Office Action Summary

10/714,383

HSU, SHIH HAO

DETAILED ACTION

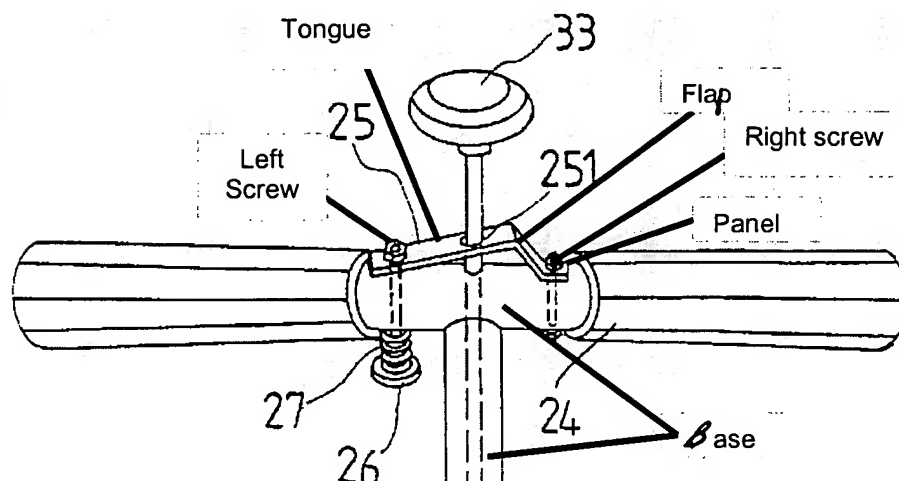
The drawings are objected to under 37 CFR 1.84(h)(5) because Figure 1 show(s) modified forms of construction in the same view. Corrected drawing sheets in compliance with 37 CFR 1.121(d) are required in reply to the Office action to avoid abandonment of the application. Any amended replacement drawing sheet should include all of the figures appearing on the immediate prior version of the sheet, even if only one figure is being amended. The figure or figure number of an amended drawing should not be labeled as "amended." If a drawing figure is to be canceled, the appropriate figure must be removed from the replacement sheet, and where necessary, the remaining figures must be renumbered and appropriate changes made to the brief description of the several views of the drawings for consistency. Additional replacement sheets may be necessary to show the renumbering of the remaining figures. The replacement sheet(s) should be labeled "Replacement Sheet" in the page header (as per 37 CFR 1.84(c)) so as not to obstruct any portion of the drawing figures. If the changes are not accepted by the examiner, the applicant will be notified and informed of any required corrective action in the next Office action. The objection to the drawings will not be held in abeyance.
